20-056MSP – BRIDGE PARK, BUILDING F1 – SPRINGHILL SUITES

This is a request for review and approval of a Master Sign Plan (MSP) application for Bridge Park, Building F1 – Springhill Suites.

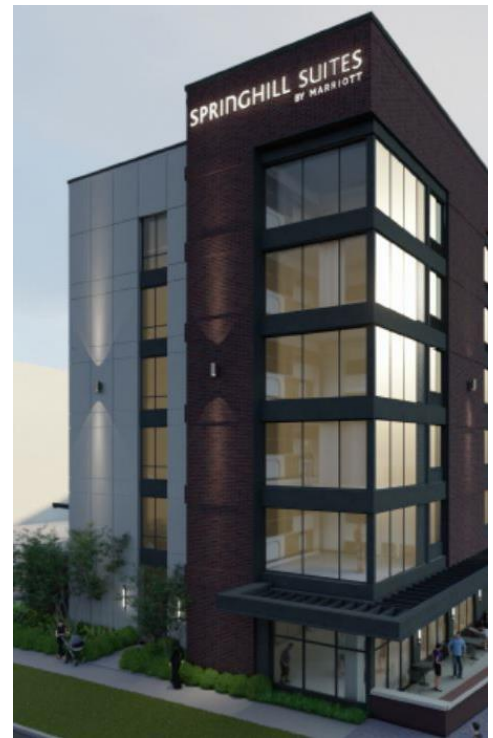
The north wall sign, indicated by the letter 'B' on the site plan, is approximately 2'-8" in height and 18'-10" in width, for a total area of approximately 50 square feet – consistent with the maximum size permitted by throughout Bridge Park. The sign faces Bridge Park Avenue to the north, and is situated immediately above the entry into the hotel lobby. Staff is concerned that the channel letter design is not of an appropriate design quality at street level, and recommends that the design of this pedestrian-oriented sign be revised to an individually pin-mounted, halo-illuminated sign, subject to Staff approval.

Criteria Met with Condition. The proposal is consistent with the purpose and intent of the BSD Sign Design Guidelines to create a vibrant, walkable mixed-use district by allowing additional flexibility and creativity in sign design. However, Staff recommends that the north wall sign be revised to be a pin mounted, halo-illuminated sign, subject to Staff approval.

- 1) That the north wall sign be revised to a pin-mounted, halo-illuminated sign, subject to Staff approval.
- 2) That the applicant provide Planning with an updated plan that incorporates all conditions of approval prior to issuance of sign permits.
